University of South Carolina
Longstreet Theatre Shutter Replacement

State Project Number: H27-6100-F

February 20, 2015

ADDENDUM NO. 2

PROJECT NUMBER	14066
SHEET NUMBER	A400
SHEET NAME	ELEVATIONS
DATE	01/09/15

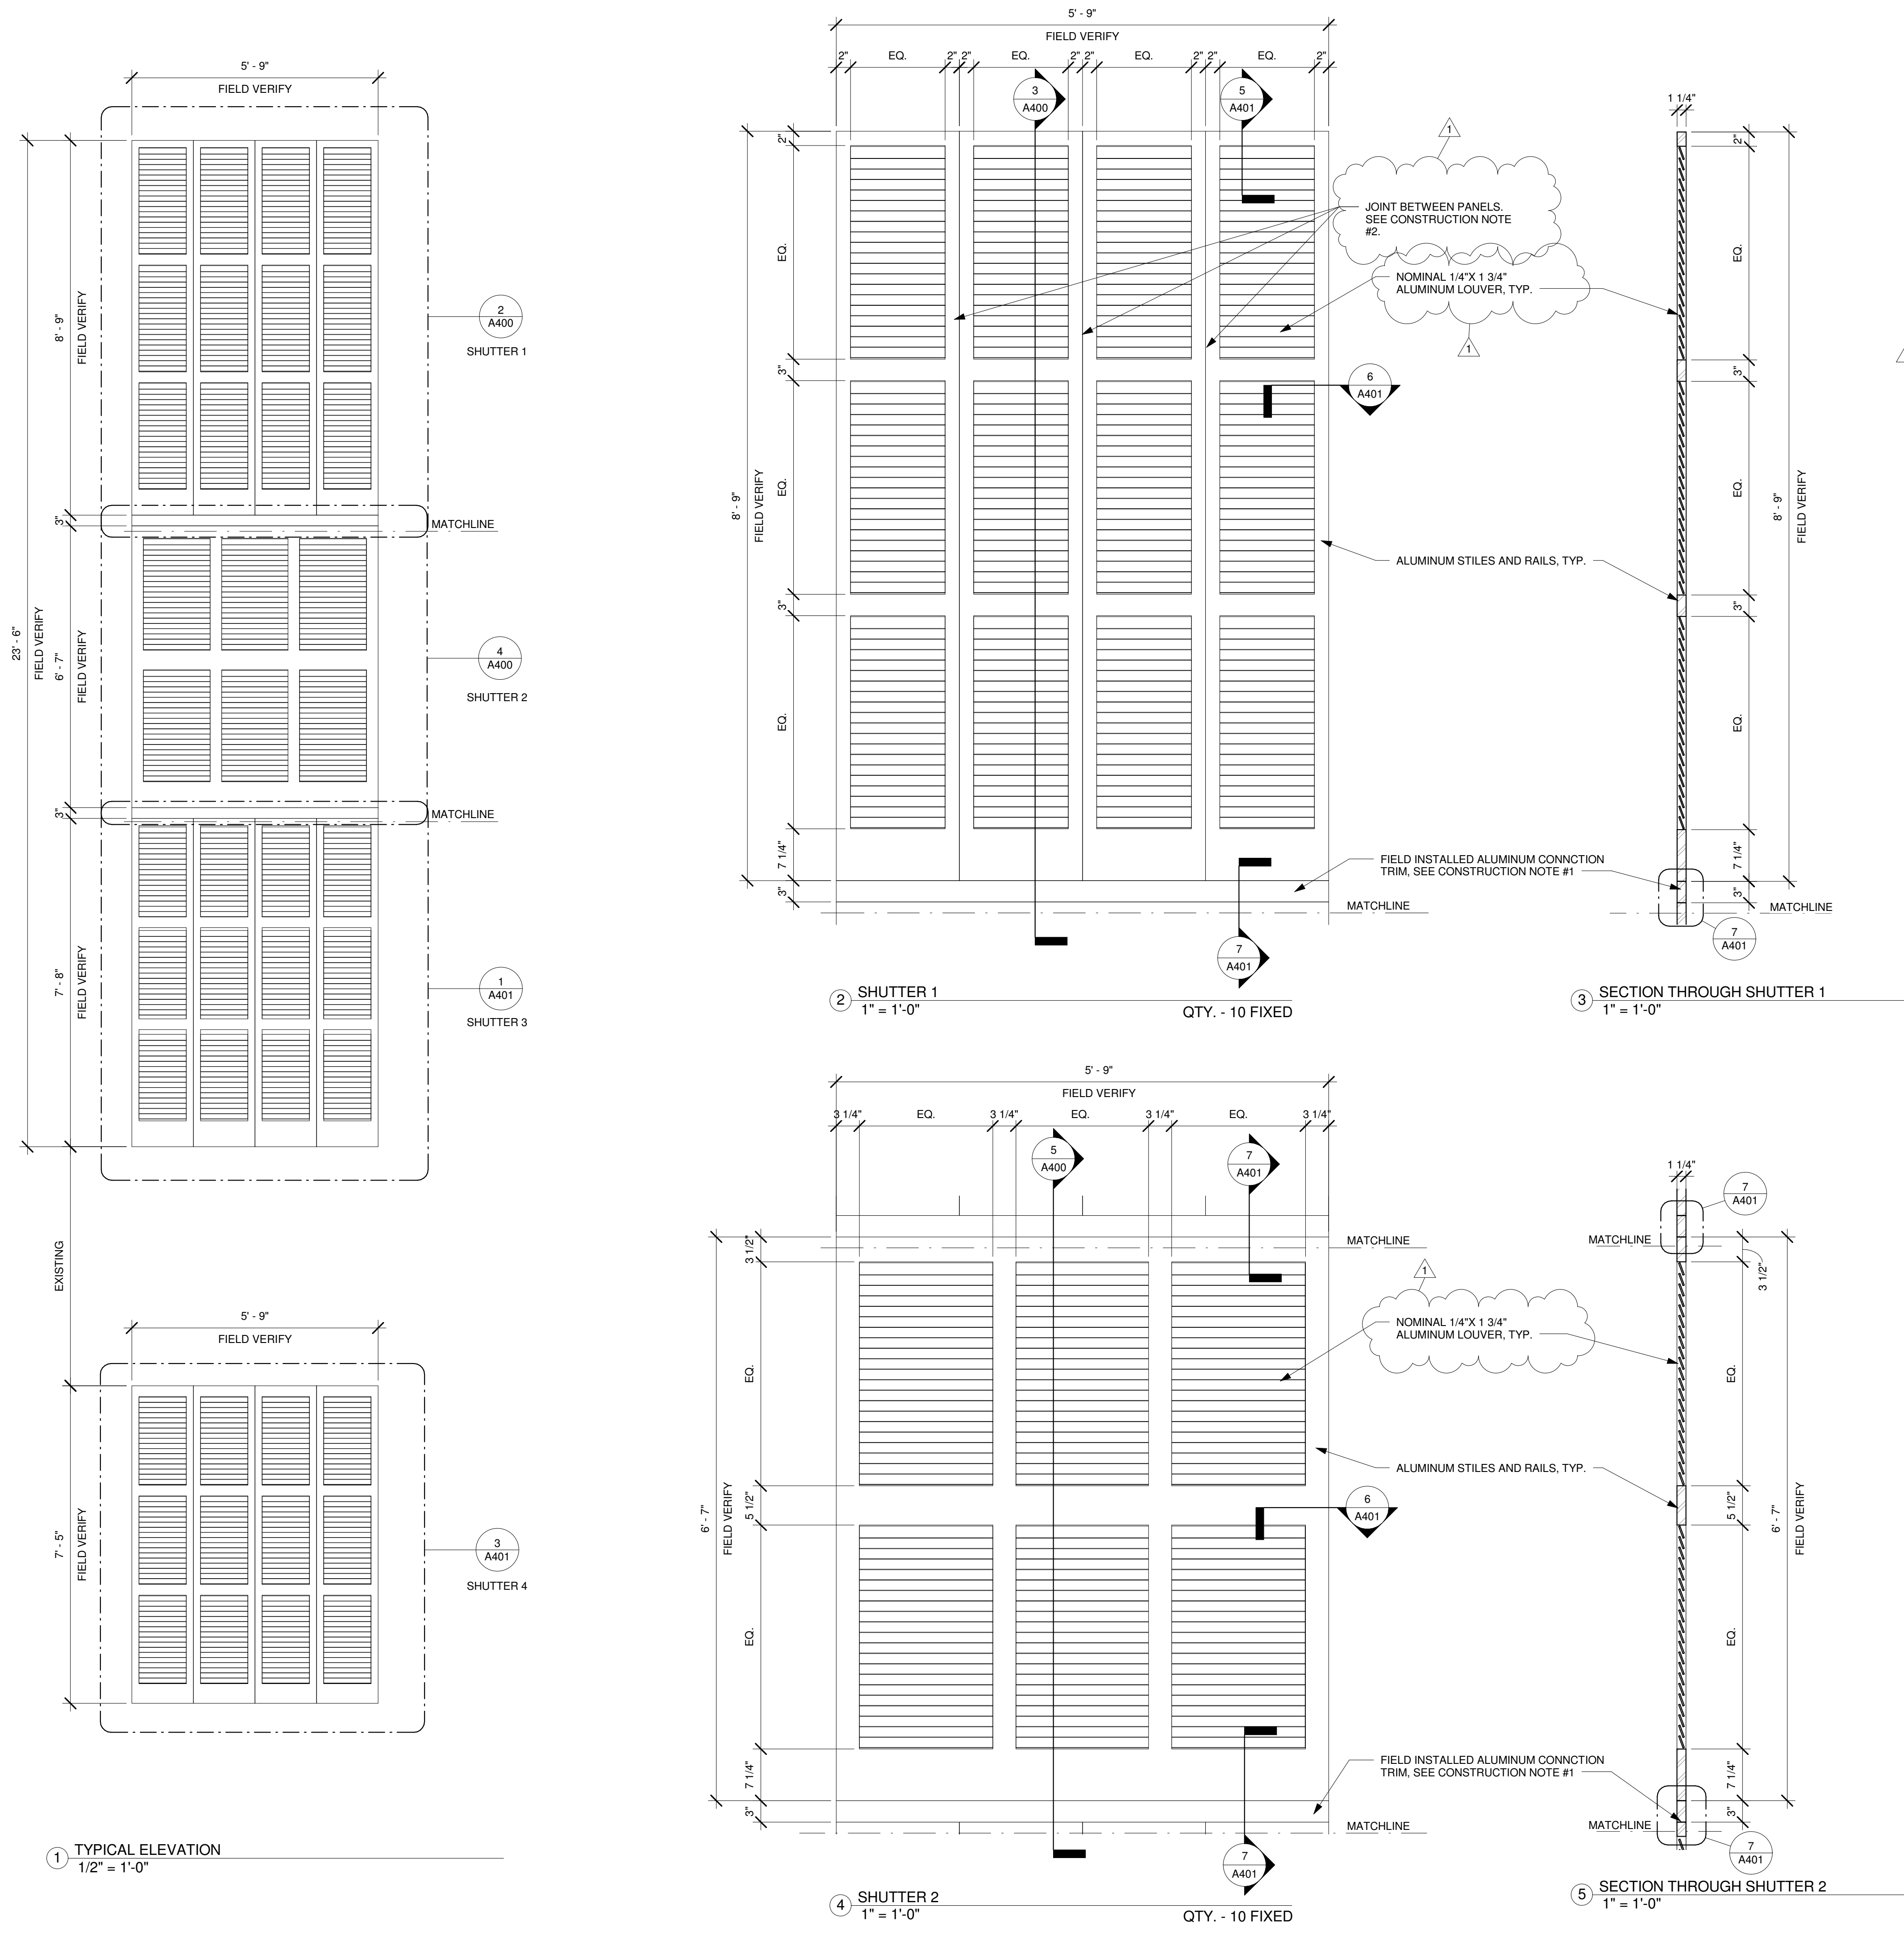
1. Reference Sheet A400: DELETE sheet A400 dated 1/09/2015, ADD in its place sheet A400 dated 1/09/2015, Revised 2/20/2015.
2. Reference Sheet A401: DELETE sheet A401 dated 1/09/2015, ADD in its place sheet A401 dated 1/09/2015, Revised 2/20/2015.

- PROVIDE INSECT SCREENING AT THE BACK OF ALL SHUTTERS WITH THE EXCEPTION OF THE OPERABLE SHUTTERS, WHICH WILL RECEIVE NO BACKING.
 - ANY EXISTING STUCCO DISTURBED DURING DEMOLITION OR CONSTRUCTION SHALL BE REPAIRED WITH THE FOLLOWING STUCCO MIXES. CONTRACTOR SHALL VERIFY TYPE OF STUCCO TO BE REPAIRED PRIOR TO COMMENCEMENT.
